NRC Monitoring of the Saltstone Facility

David Brown, CHP
Sr. Project Manager
U.S. Nuclear Regulatory Commission
Office of Federal and State Materials and Environmental
Management Programs

October 2007 Observation Visit Vault Construction

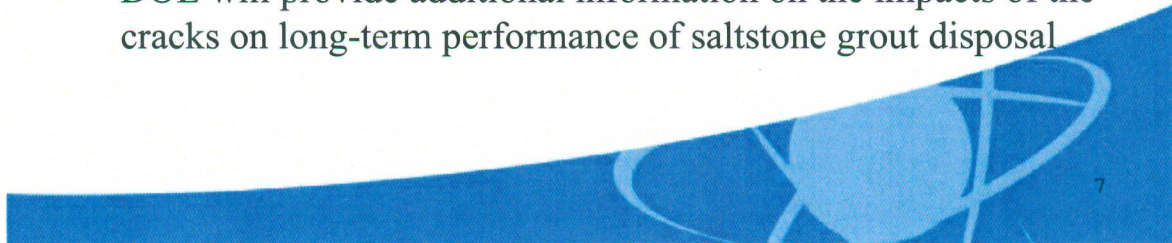
- Vault 4 was being filled during the NRC observation visit
- NRC staff observed wet cracks on the vault wall
- NRC staff requested information on whether the presence of cracks is consistent with DOE's performance assessment
- DOE will provide additional information on the impacts of the cracks on long-term performance of saltstone grout disposal
